Owner Change Order (OCO)

Project Name: Brookline - Driscoll School
Gilbane Project No.: J08864.000

OCO: OCO-0015

Scope Of Changes: OCO 15 Misc. Changes

Response to RFI-391

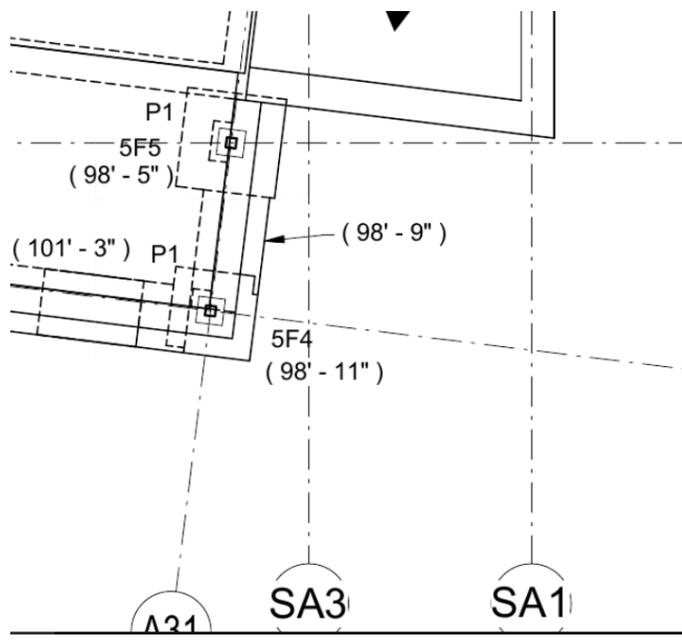
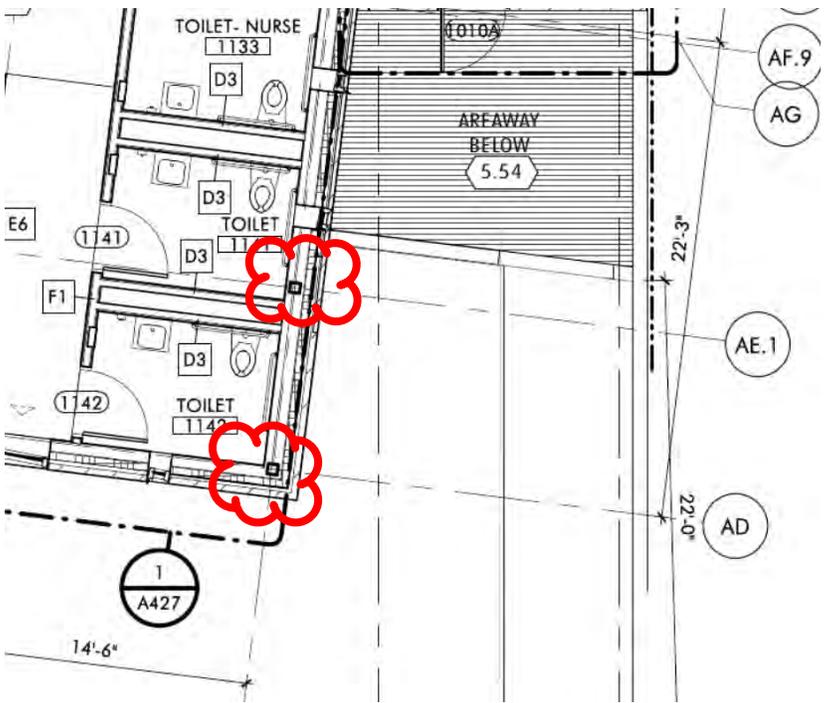
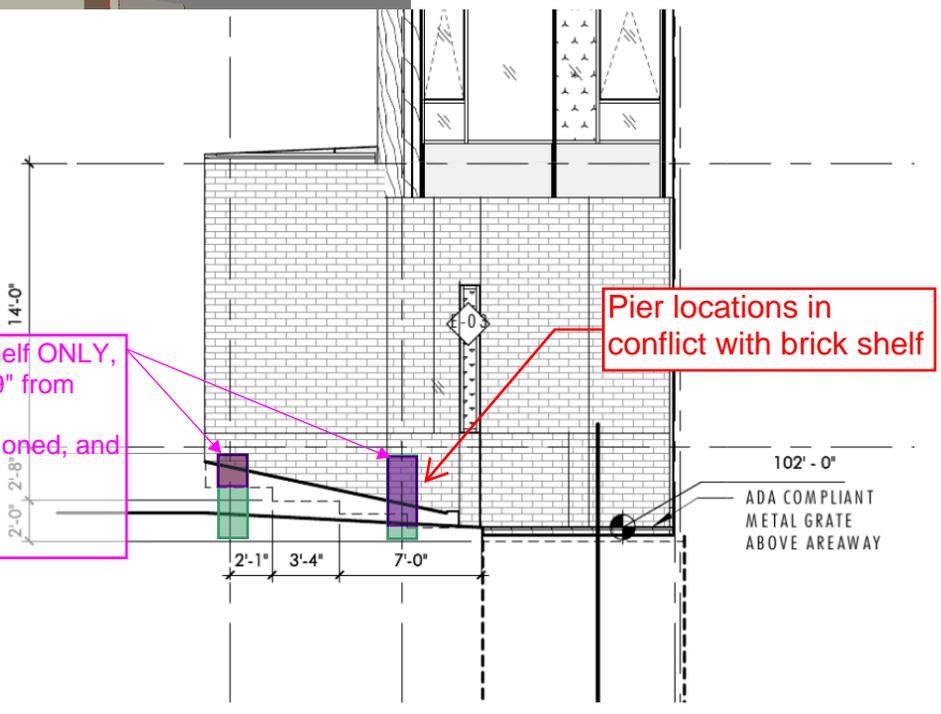
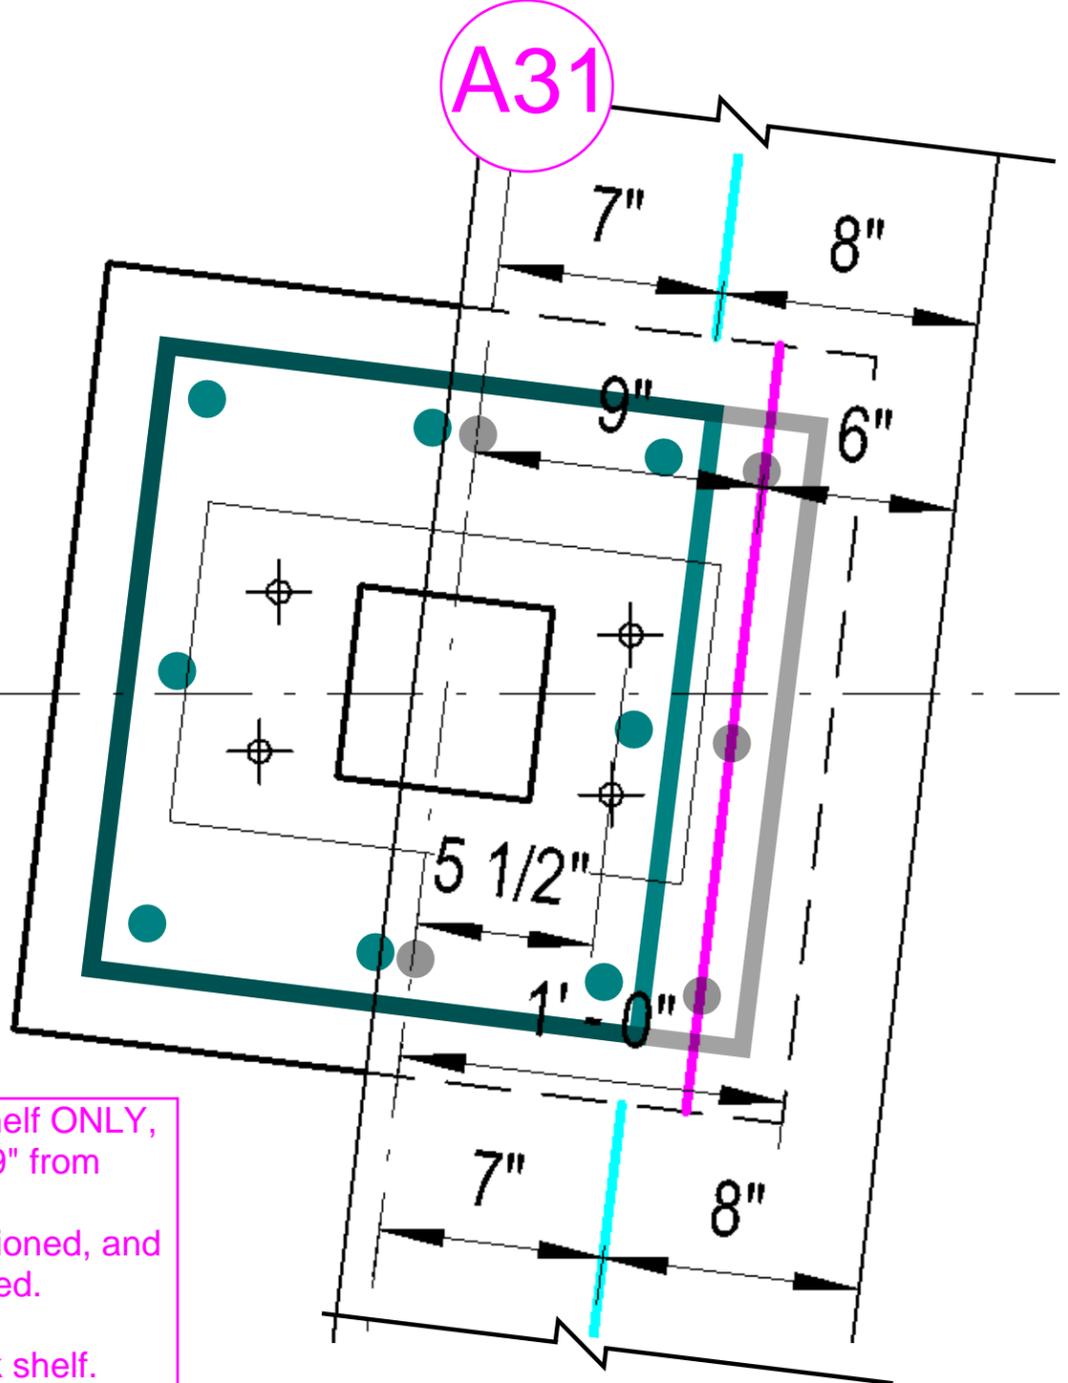
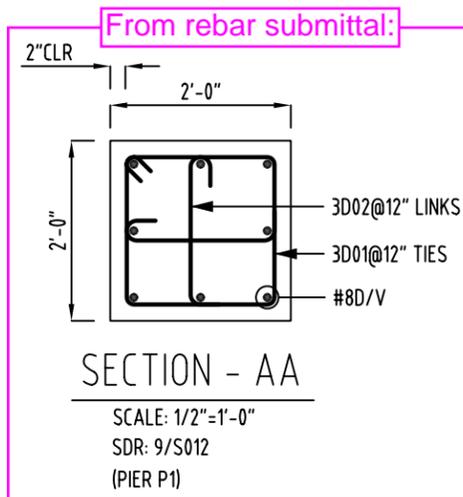
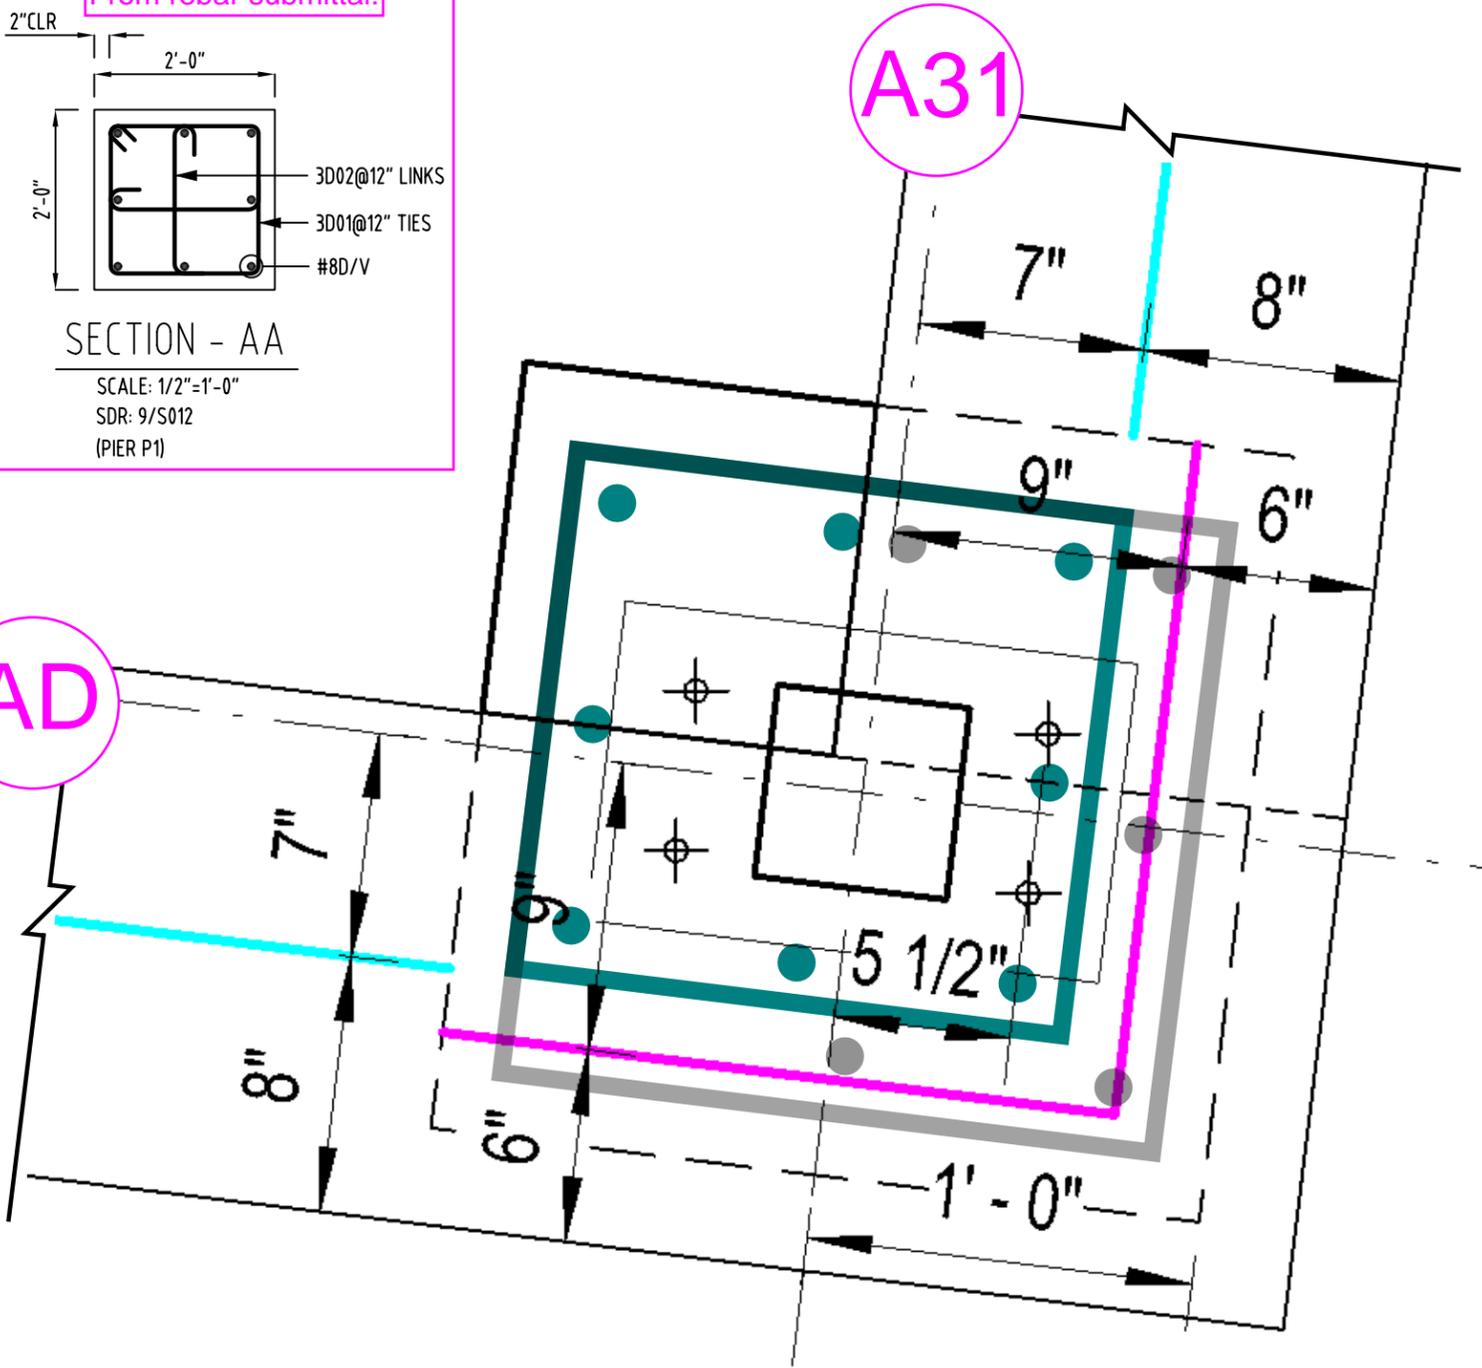
urgent There is a conflict along A31 line between the brick shelf, which steps down from elevation 105'-4" to 101'-4". The top of concrete piers at A31/AD and A31/AE remain at 105'-4". The P1 concrete pier protrudes into the brick shelf. Please advise on an acceptable detail for wall/ brick shelf along A31. See attached sketch.

For the portion of the pier above the brick shelf ONLY, revise dimension of outer face of pier to be 9" from column gridlines.
 Vertical reinforcement will need to be transitioned, and dimensions of ties will need to be revised.
 See next page for sketches in plan view.

For the portion of the pier above the brick shelf ONLY, revise dimension of outer face of pier to be 9" from column gridlines (magenta lines). Vertical reinforcement will need to be transitioned, and dimensions of ties/links will need to be revised.

Cyan lines are the usual location of the brick shelf. Vertical reinforcement and horizontal ties are shown in gray (below brick shelf) and teal (above brick shelf). Horizontal links are not shown for clarity.

1 PLAN - ROOF - OVERALL
1/16" = 1'-0"

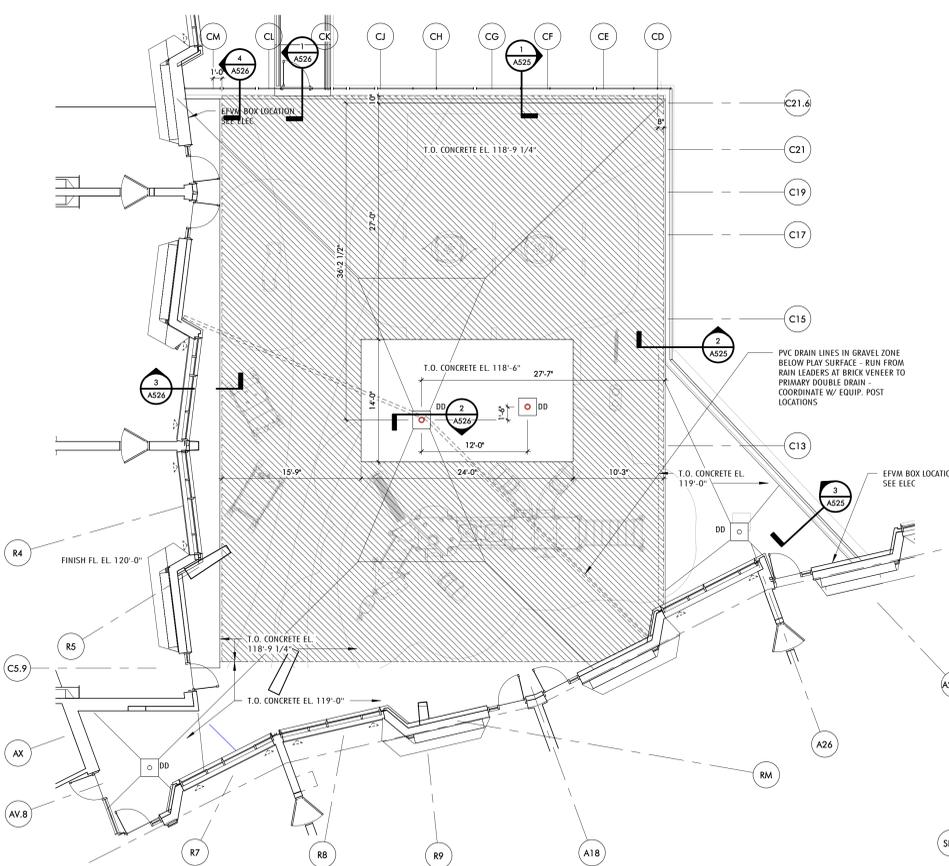
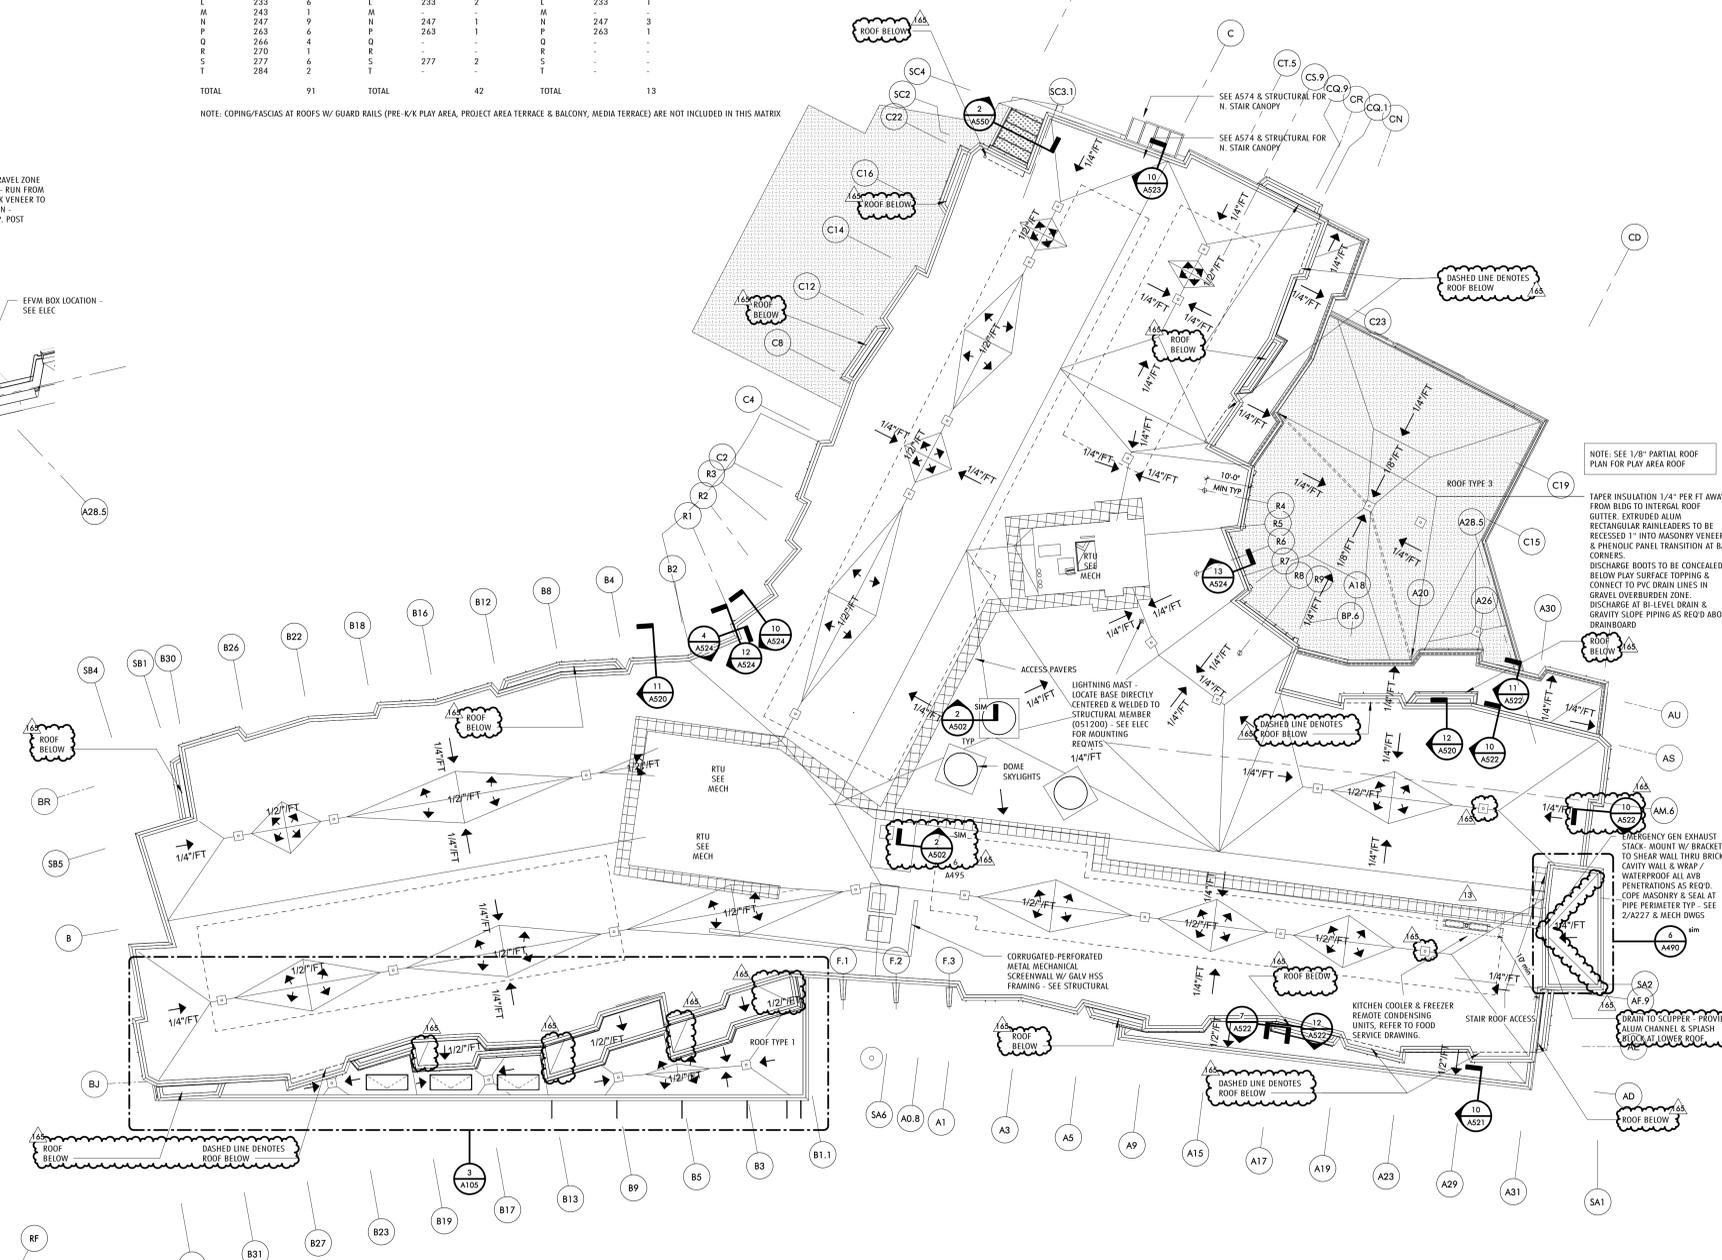
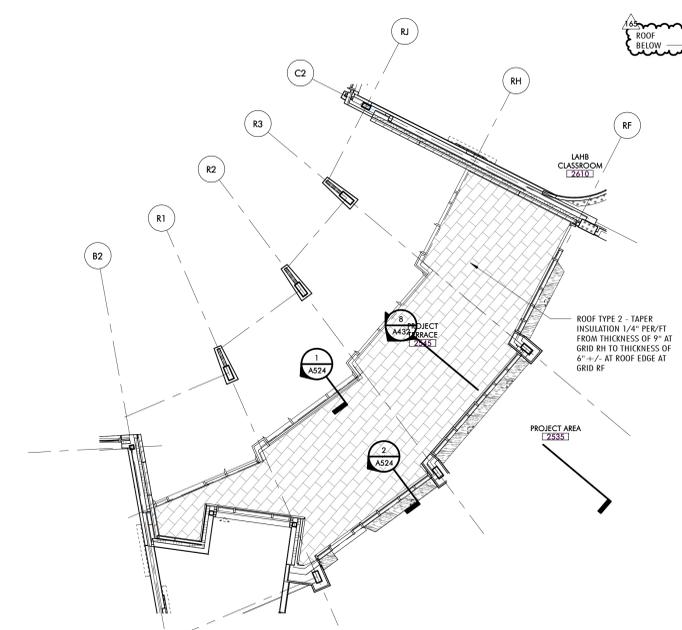
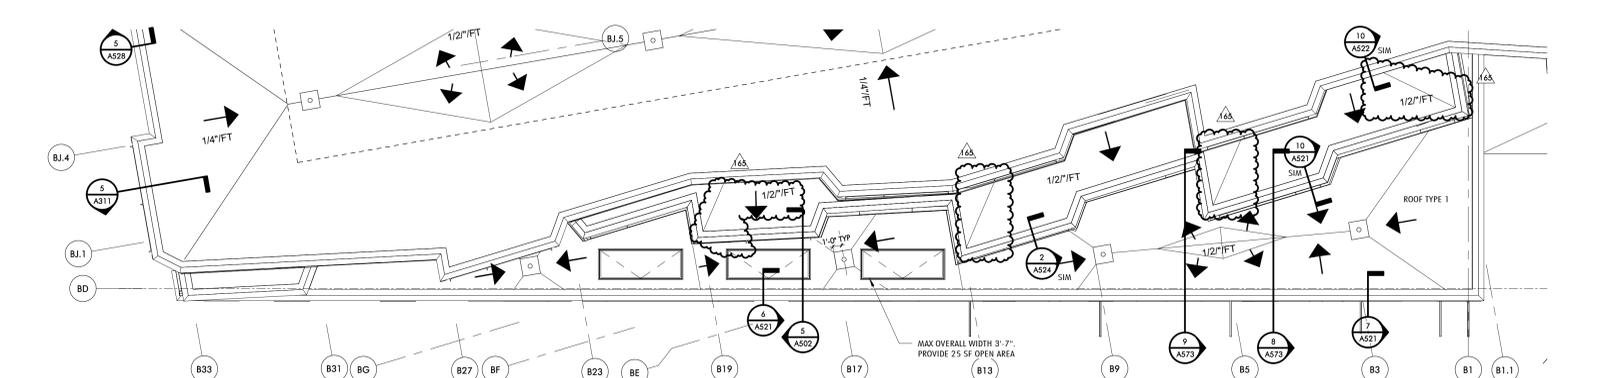
Refer to attached clarifications regarding window bay roof locations & roof extents at lower floor levels noted on sheet A105.

1. Clarification of roof extents on overall roof plan showing all minor roofs at lower occupied levels.
2. Roof slope clarifications at Area B level 4 and Stair 1 per tapered insulation submittal review.
3. Roof drain location clarifications per 5/10/22 sketch at Area A roof.
4. References to section details 2/A502 (elevator penthouse) and 10/A522 (typical roof edge detail at brick) added to roof plan for clarity.
